MARK	DATE	DESCRIPTIONS	BY	CH'D	CCO#
1	12/10/10	MISCELLANEOUS ELEVATOR DETAILS	TH	MN	174

SAN FRANCISCO OAKLAND BAY BRIDGE
EAST SPAN SEISMIC SAFETY PROJECT
SELF-ANCHORED SUSPENSION BRIDGE
(SUPERSTRUCTURE & TOWER)

TOWER SHAFT DETAILS NO. 8

TYPICAL TOWER BASE CROSS SECTION

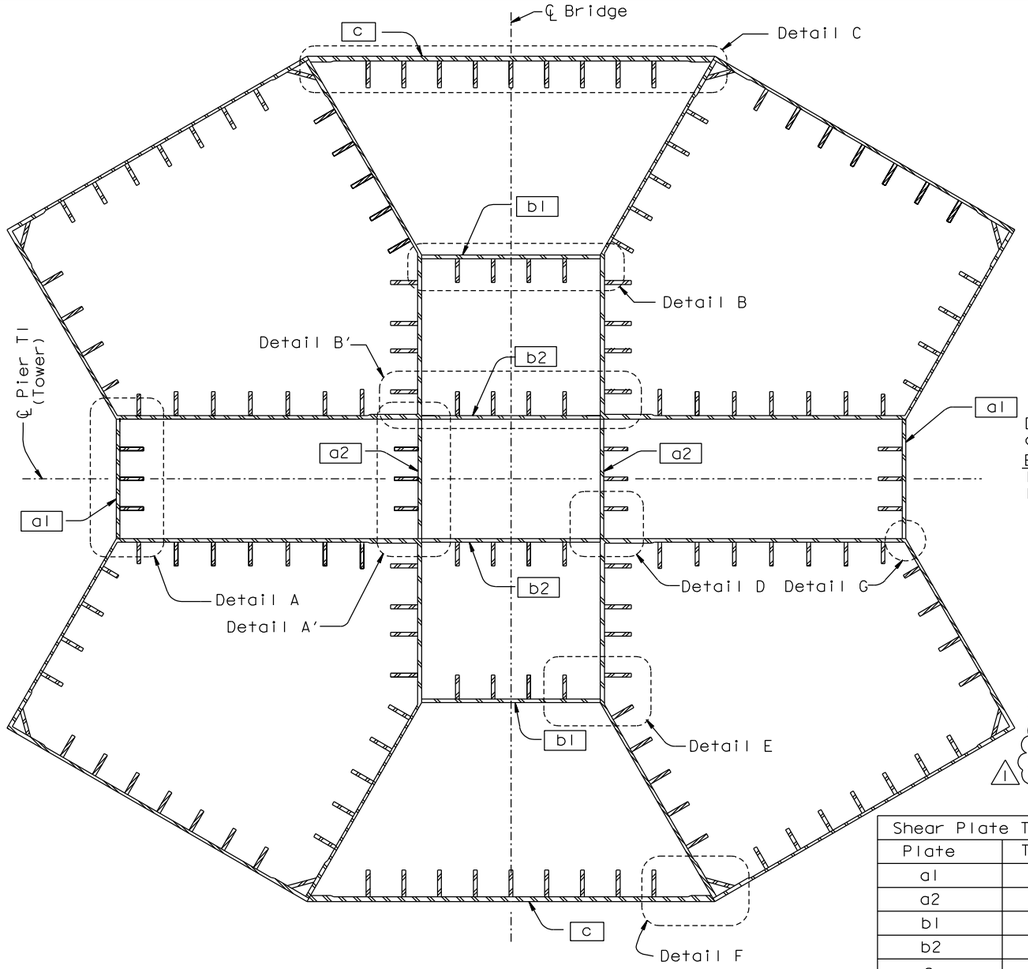
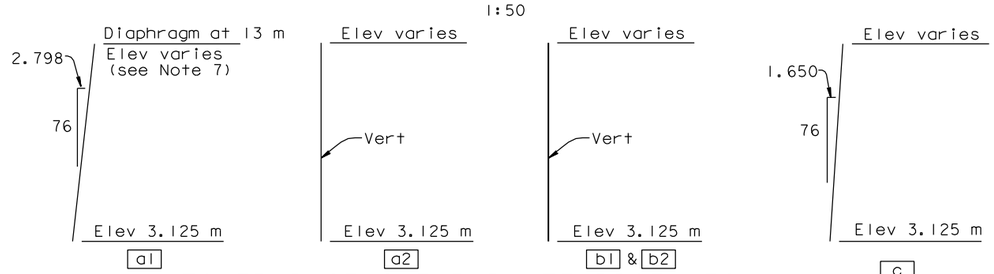
8. Access openings in tower base shear plate [c] shall be on East side of tower only.
9. At the Contractor's option, temporary access openings may be provided at locations shown in shear plates [a1] only. The openings shall be closed with fill plates which shall be identical to the respective shear plate. The fill plates shall be CJP welded all around. △1
